OBJECTION TO
PLANNING APPLICATION REGISTER REFERENCE SD21A/0354

Application Date: 21/12/2021
Applicant: Amy & John Ennis
Location: Rear of 66 Dodsborough Cottages, Lucan, Co. Dublin
Proposed Development: Construction of detached, single storey bungalow; new vehicular access to the Dodsborough Road (Adamstown Boulevard); car parking to front garden; new landscaping and boundary treatments and associated site works.
Decision Due: 23/02/2022

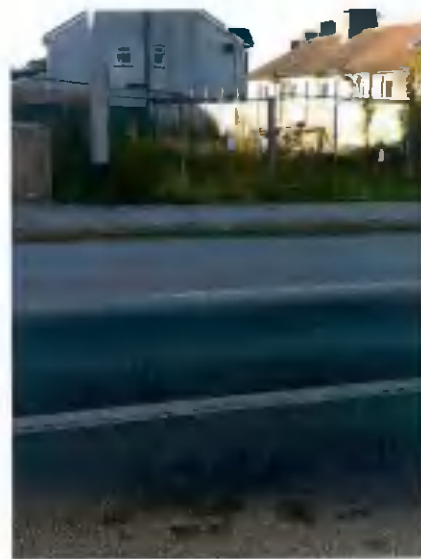
The Site Notice is illegible from the public footpath. The Notice is mounted on a timber post that is set back 1.8m from the rear of the footpath (public property), and 0.7m from the steel fence that is erected 1.1m behind the footpath on private property. The Notice is covered in a loose plastic sleeve which has become fogged-up rendering it illegible. This is not in accordance with planning requirements and could call into question the validity of the application. (See photographs below taken on 17 Jan 2022).

We note that the proposed contiguous buildings elevation misrepresents somewhat the extent of the front wall of the bungalow to the south, the location of the existing ESB pole and layout of the proposed new entrance. In addition it fails to show the rear elevation of our home, upon which the proposed building would have a such a significant negative impact. (See photographs below taken on 17 Jan 2022)
